**LISTED BUILDING ENFORCEMENT NOTICE**

**ISSUED BY:**        **NORTH EAST LINCOLNSHIRE COUNCIL**

Land at 1-3 Bethlehem Street, Grimsby, North East Lincolnshire, DN31 1JN, (“the building”) shown edged in red on the attached plan.

Photo 1 – Showing lights 1 – 6 on Wellowgate

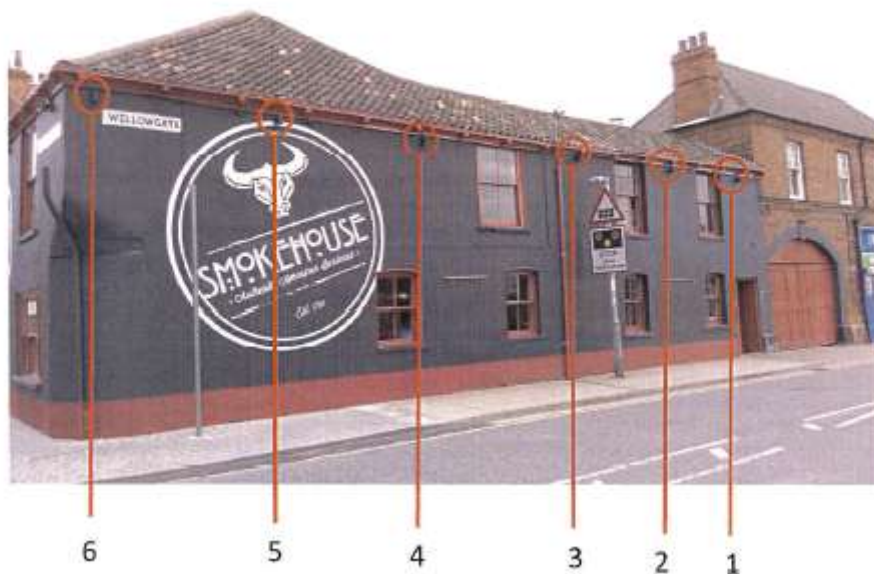
- 3.3    The re-painting of the rendered plinth in red from black (Photo 7).
- 3.4    The addition of 12 exterior down lights and associated wiring (see Photos 1 and 2).

5.1 Remove all 12 external lights (see Photo 1 and Photo 2), their fittings and electricity supply (using a competent and approved electrician).

Photo 8 – Showing missing spindle (Ground Floor Spindle One)

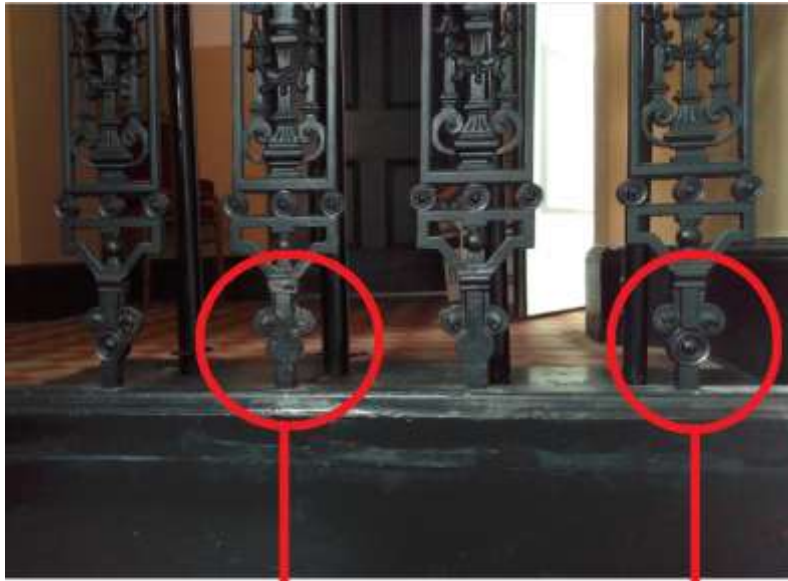
replaced incorrectly (see Photo 10) and 1 being missing (see Photo 8).

- 5.10 Locate the missing spindle from Photo 8. If the missing spindle cannot be located create a new spindle matching exactly (in design, size materials and finish) those already in place and insert into the gap making sure not to cause damage to the banister or footplate. The moulded side should face outwards, away from the footplate as per correct spindle in Photo 9.

Photo 9 – Showing orientation of spindles

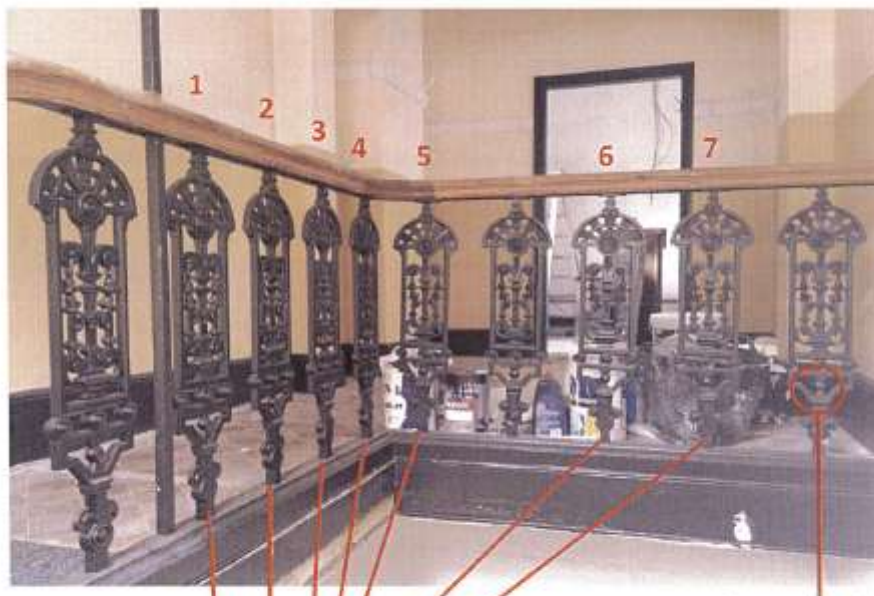
Incorrect facing  
spindle – mould  
facing the footplate.

Correct facing  
spindle – mould  
facing away from  
the footplate.

- 5.11 Carefully remove the 7 spindles which are orientated incorrectly (see Photo 10) making sure the banister and footplate is not damaged. Replace these spindles so that they match the remaining spindles (see Photo 9) in orientation.

**Photo 16 – Showing painted Joinery and Rain Water Goods.**

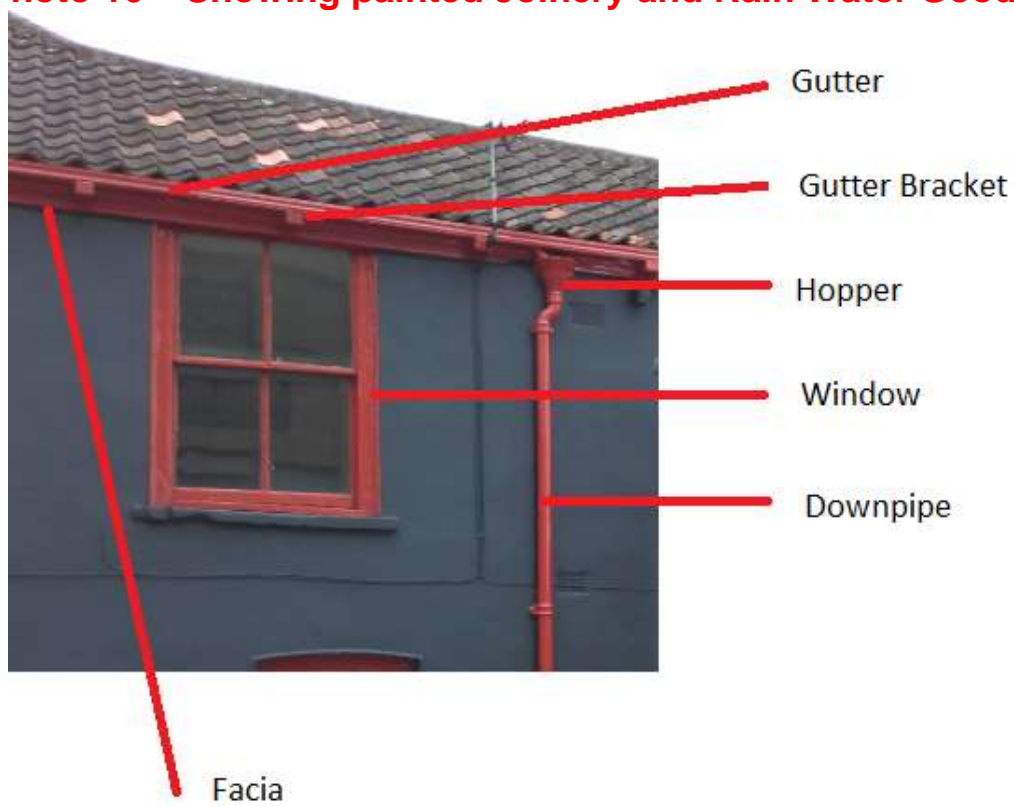
- 3.1    The re-painting of the exterior render and masonry arch in black/grey from white/cream (see Photo 6).
- 3.2    The re-painting of exterior joinery (windows, doors, fascia, gutters and gutter brackets) and rain water goods (hoppers and downpipes) in red from black (see Photo 16).

- 5.7 Repaint joinery (windows, doors, fascia, gutters and gutter brackets) in black gloss having first appropriately primed, ensuring to paint over the glazing putty for a weather tight seal.

- 5.8 Re-paint rainwater goods (hoppers and downpipes) in black gloss.
- 5.9 Reinstall painted plinth in black gloss which is level with the masonry plinth which includes painting the masonry plinth at the base of the arch to the footpath (see Photo 7).

**Photo 18 – Showing painted SMOKEHOUSE sign on  
Bethlehem Street elevation.**

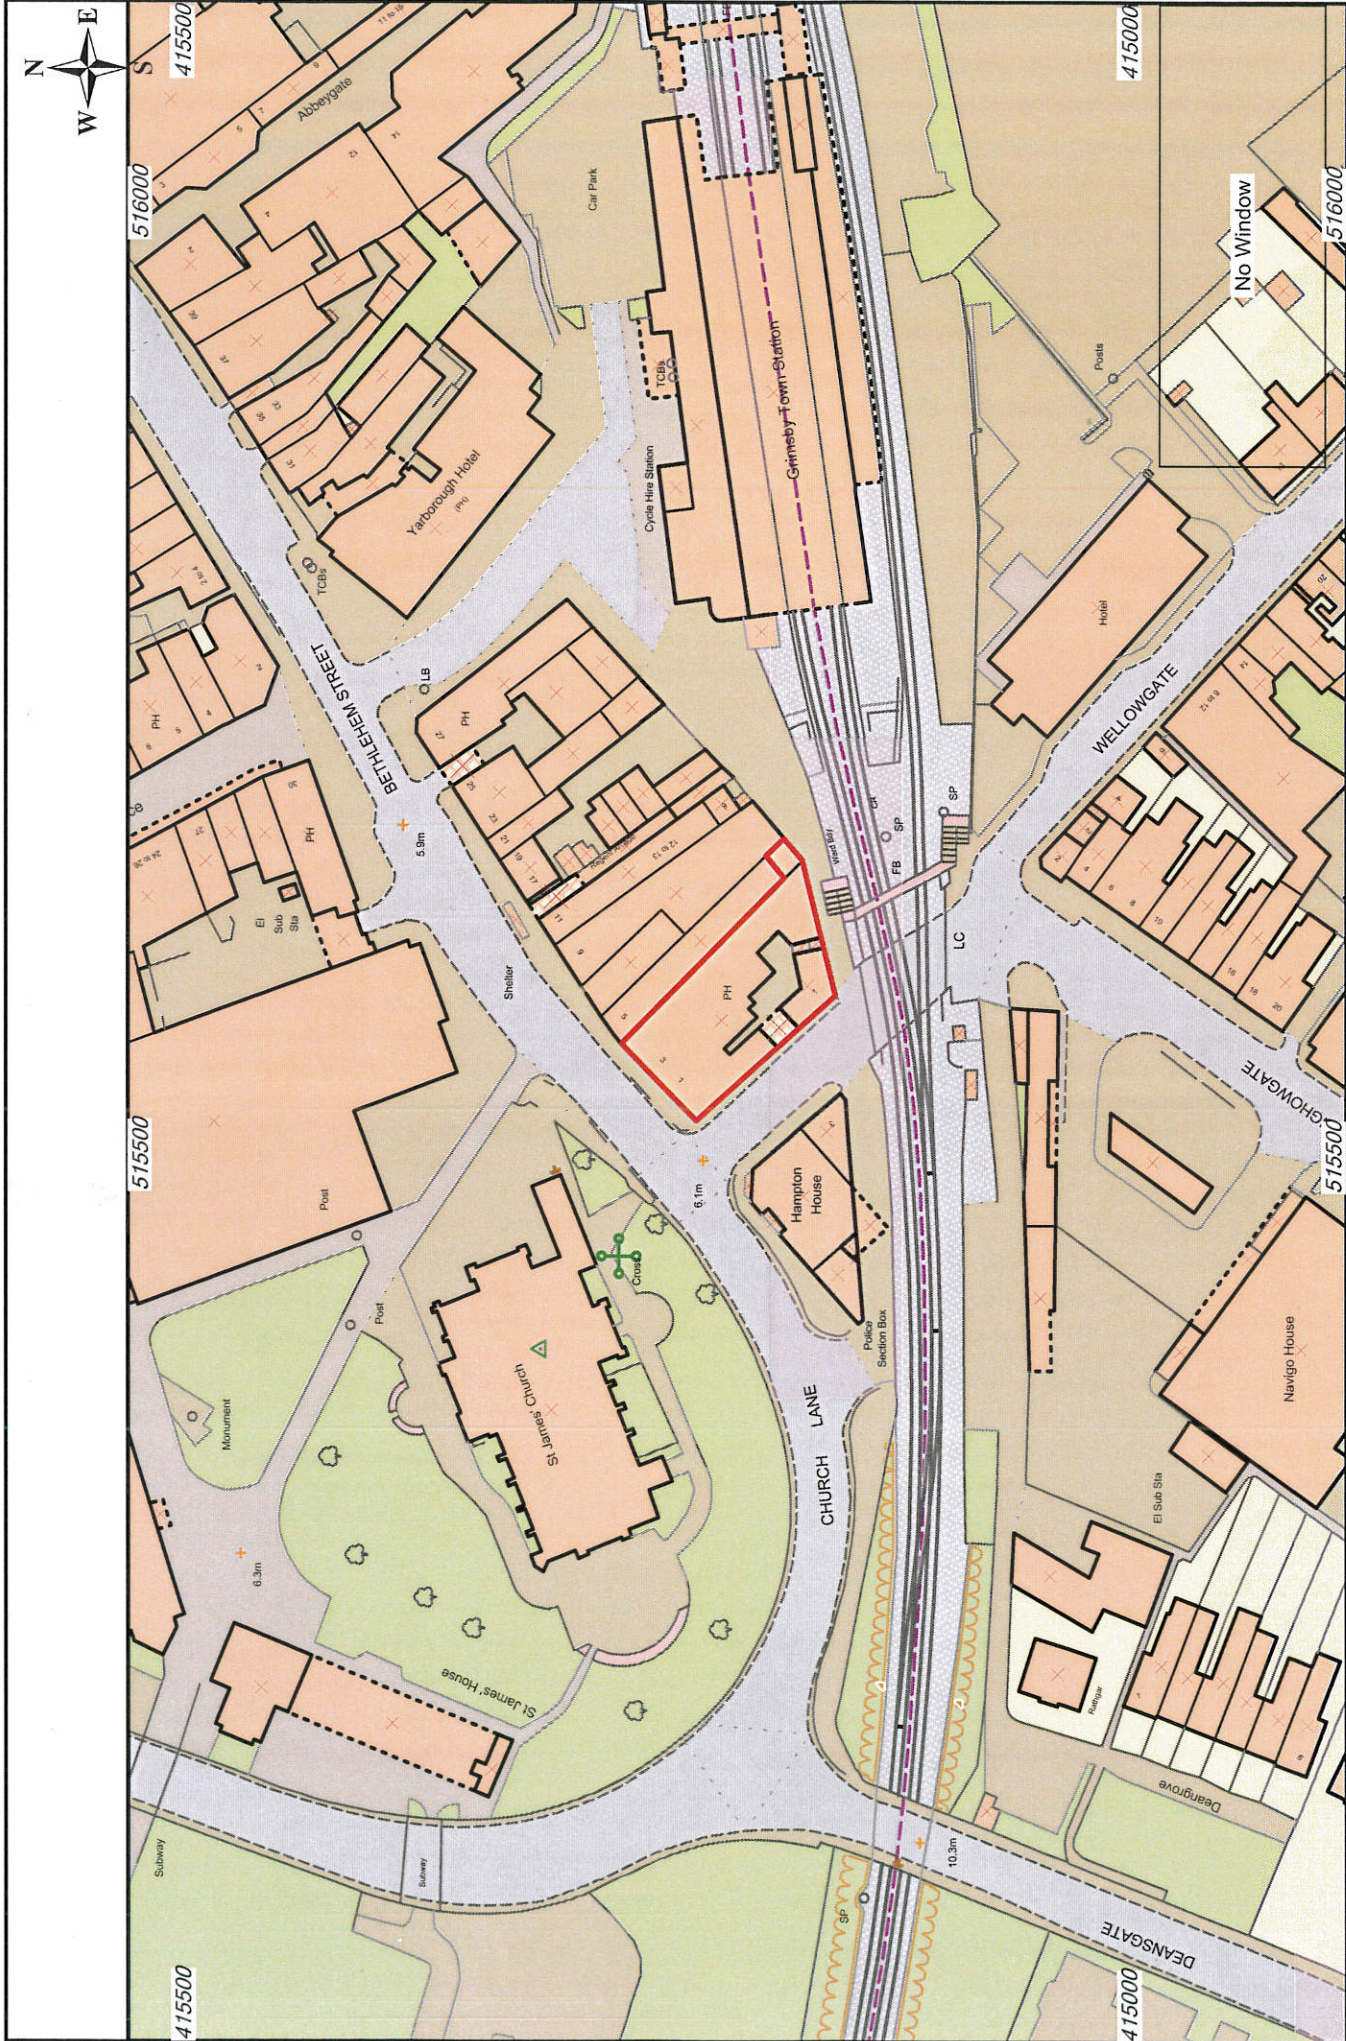
- 3.5    The addition of 2 exterior painted SMOKEHOUSE advertisements (see Photos 17 and 18).
- 3.6    The addition of 4 hanging apparatus which are used for the display of advertisements (see Photos 3 and 4).

5.5 Remove current paint from the external render and masonry using an appropriate method following manufacturers guidelines. This includes removing the two hand painted smokehouse signs. Once clean and dry any holes or cracks in
